Department of Transportation

MEMORANDUM

SUBJECT: Supplemental Report for BZA Case No. 20014 – 1803 Rhode Island Avenue NE

Figure 1. Parking Occupancy Study Area (Source: Symmetra Design, Transportation Study, Figure 3, 10/9/2019)

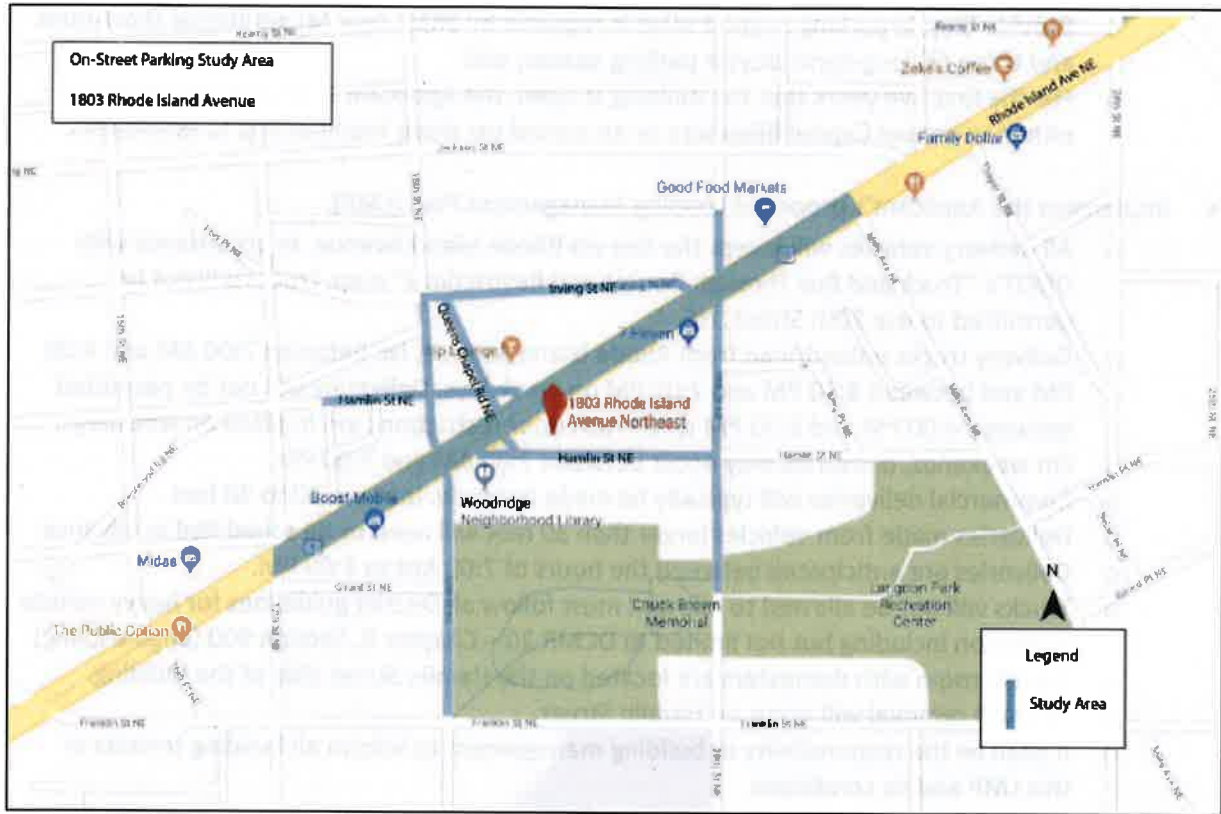
The Applicant is required to provide and is seeking relief from all 13 vehicle parking spaces. In situations where an Applicant is requesting relief from five (5) or greater vehicle parking spaces, DDOT requires an on-street parking occupancy study to understand the action's impact on neighborhood parking conditions. The Applicant worked with DDOT to scope an appropriate study area, as shown in Figure 1. Symmetra Design conducted an analysis of observed on-street vehicle parking conditions during weekday and weekend peak periods within a two to three block radius on the site. As seen in Figure 2, there is a significant amount of unrestricted parking in the vicinity of the site.
